Revision: J
Our ref: 12548316

RE: New High School in Jerrabomberra SSD RFI

Table 1 DPIE RtS Letter

**Detailed Submission - New High School at Jerrabomberra (SSD-24461956)
Objection to Proposal**

Environa Drive/Stub road intersection

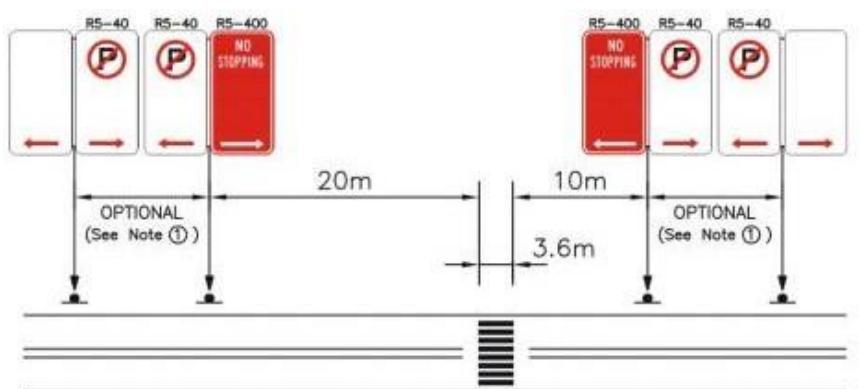
That the applicant be requested to revisit the need and proposed location for a school crossing adjacent to the main school entry off the north road. (Objection)

That the applicant be requested to provide further information on how the movement of pedestrian from the western side of Environa Drive can be discouraged. (Objection)

Intersections and Crossings. The Technical Direction specifies that to provide suitable sight distances and support the safety of pedestrians at mid-block pedestrian crossings, No Stopping signage should be provided 20 m prior to the crossing and 10 m after the crossing as shown in the diagram below.

The stub road provides a single lane in either direction, and the provision of these No Stopping zones on the stub road (which would be required in both directions) **is not consistent** with its geometry or the operation of the kiss n drop zone and as such, this option is not considered feasible.

Accordingly, the intersection of the stub road with Environa Drive will be the location for the school crossing. The *TfNSW Supplement to Austroads Guide to Traffic Management part 10: Traffic Control and Communication Devices*, specifies that for crossings used predominantly by school children, in two counts of one-hour duration immediately before and after school hours, a zebra crossing is warranted if:

**Services Plans (not WAE) – 300 Lanyon Drive (to become 101 Environa Drive)
Jerrabomberra**

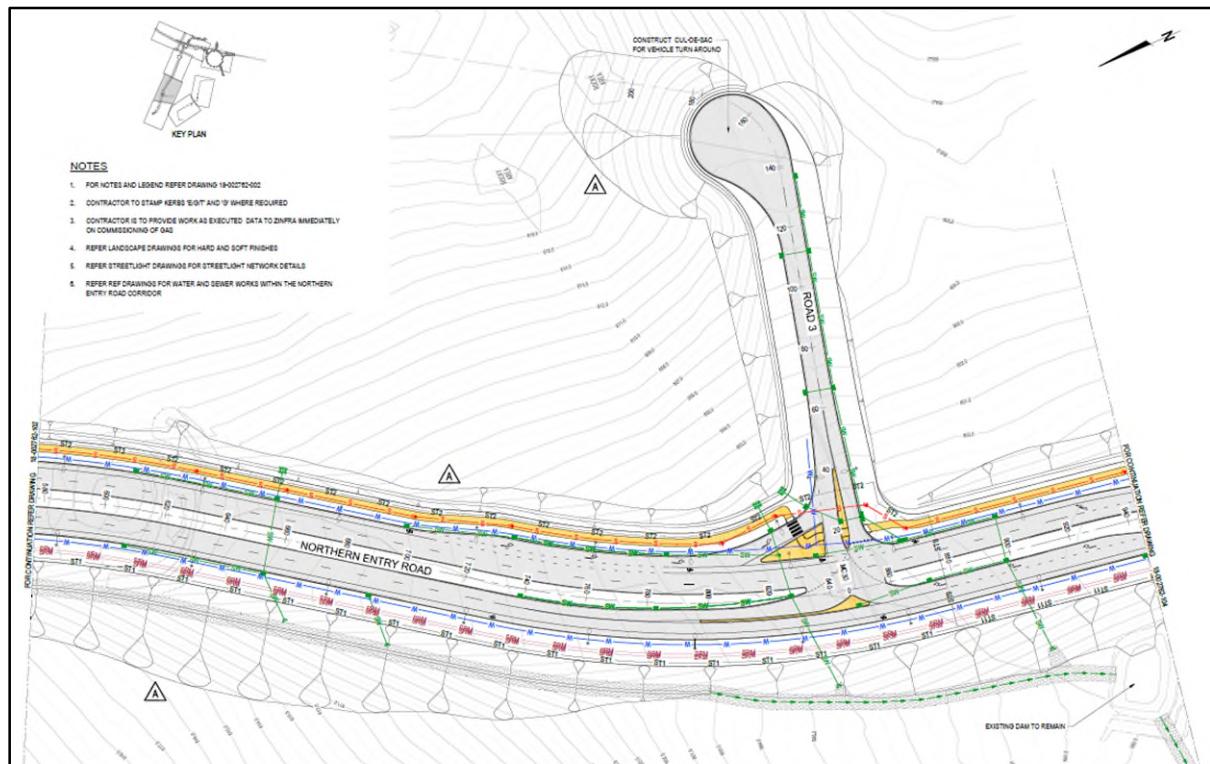
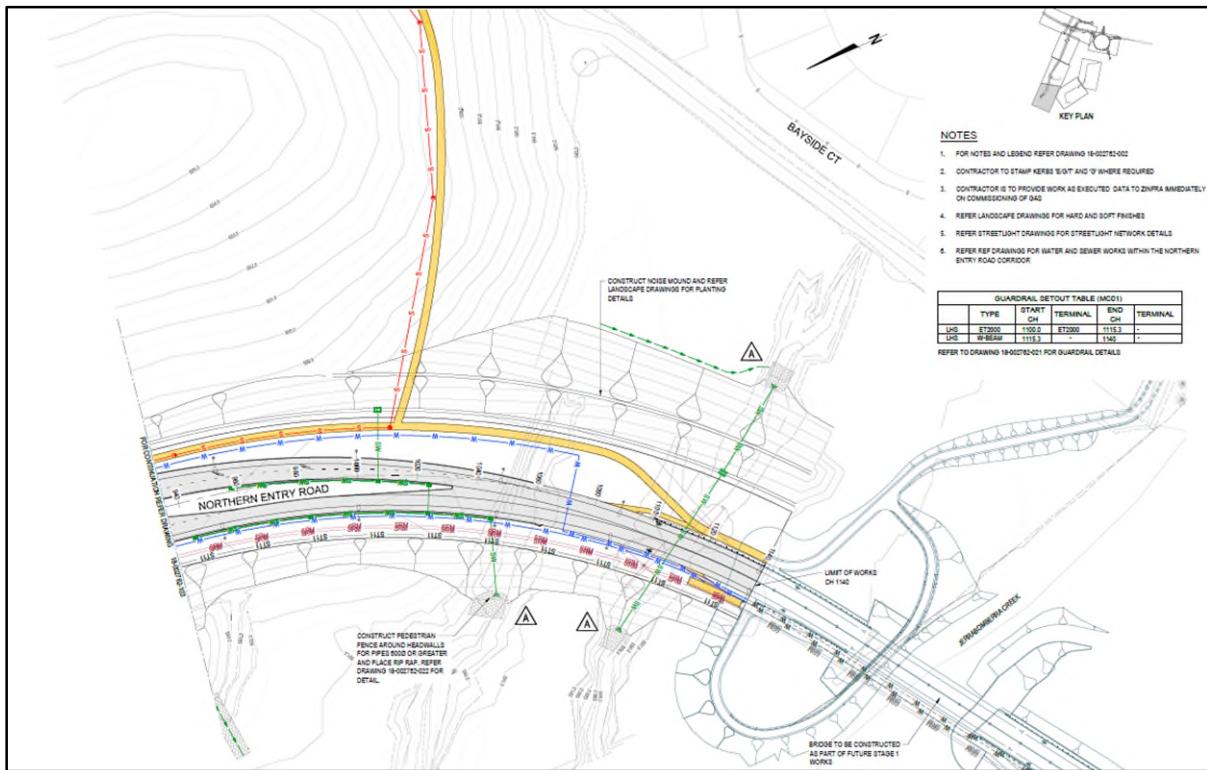
Figure 4 in the plan shows sewer connection to manhole S112 near the Bus Zone. The sewer connection should be through a standard connection to the sewer main running towards the rear of the school block.

The high school development site can be serviced by a storm water connection to the recently constructed pit (G02) adjacent to the Bus Lane with a 600mmØ RCP drainage pipe connecting to the new infrastructure line in Environa Drive.

- Preparation of a hydraulic design plan providing details of the required sizing for all water, sewer and stormwater services required for the site.
- The preparation of an on site detention design to limit stormwater discharge from the site to pre-development flows.
- That all connections and alterations to Council's utility services are inspected by Council staff prior to backfilling.

Drawing Title
Pedestrian Road Safety - Barrier Fence

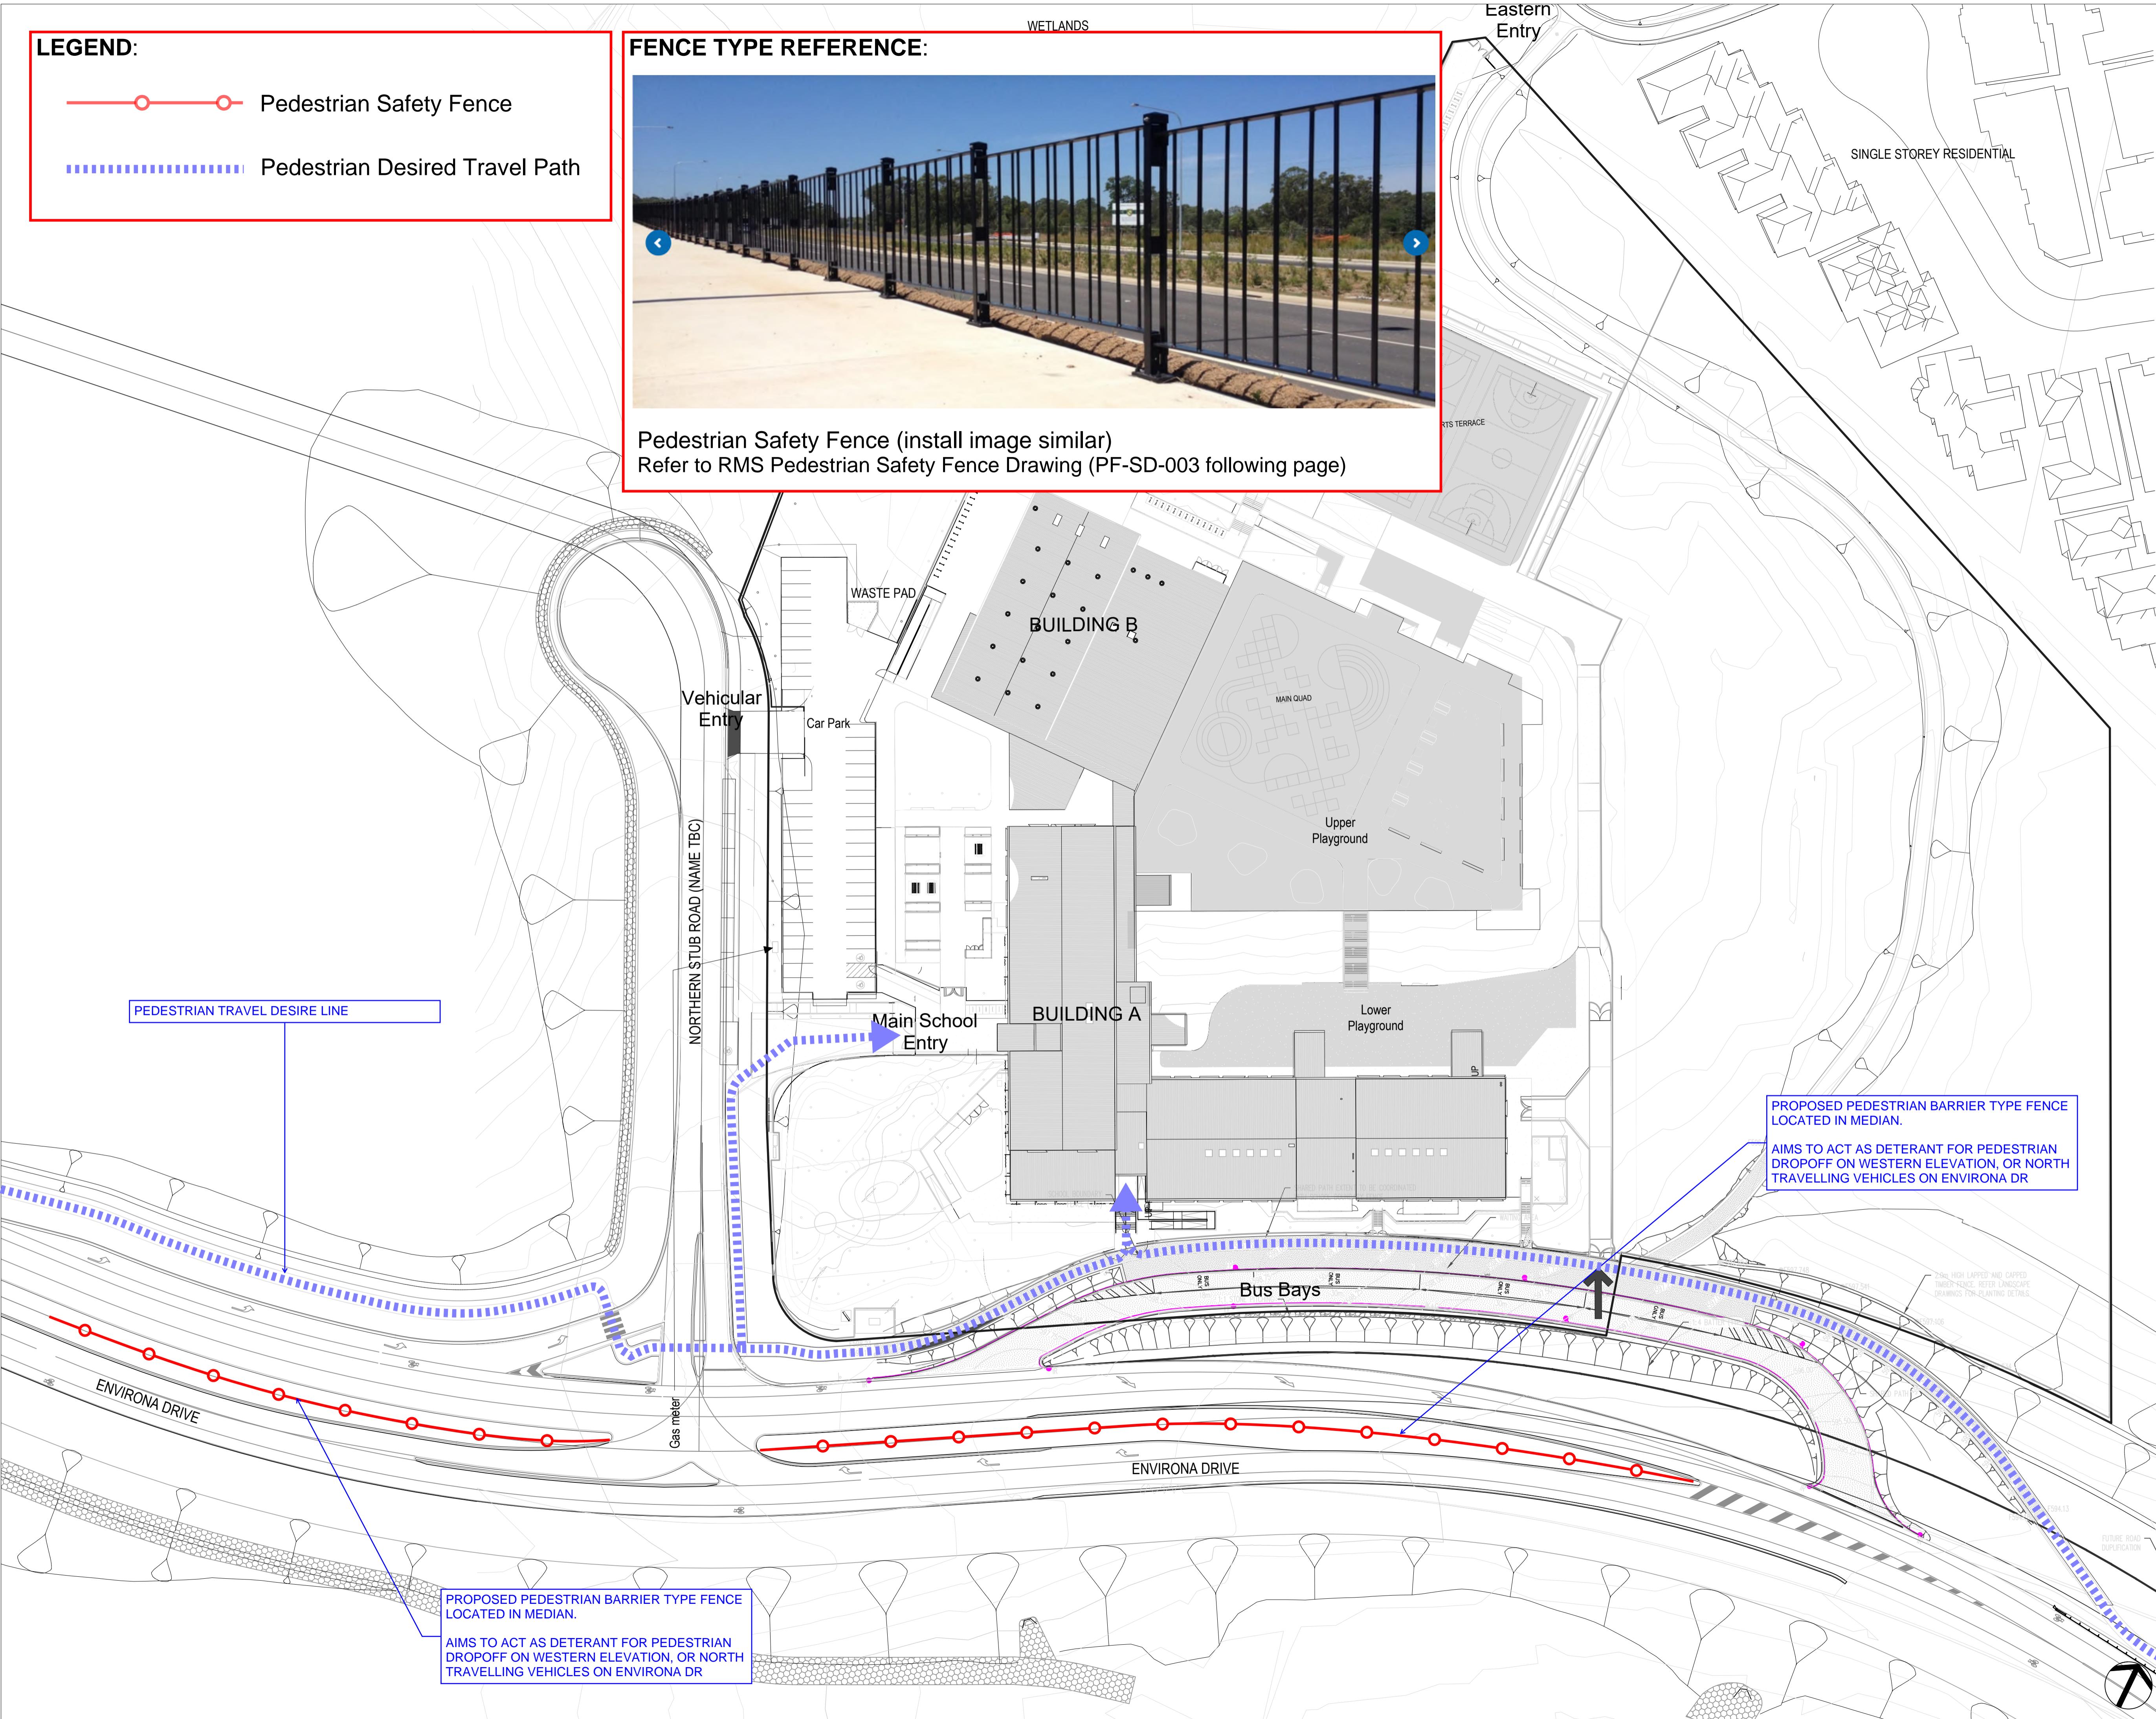
Fencing will also be provided within the median of Environa Drive to discourage students from being dropped off / picked up on Environa Drive, with the location/alignment shown on drawings provided in Appendix E; Pedestrian road Safety-Barrier Fence TP-0001 and fencing type illustrated in, Type 1 Pedestrian PF-SD-003.

Details relating to the fencing (type, location/alignment, extent) will be further developed by the design team (civil designer/landscape architect) as the project progresses.
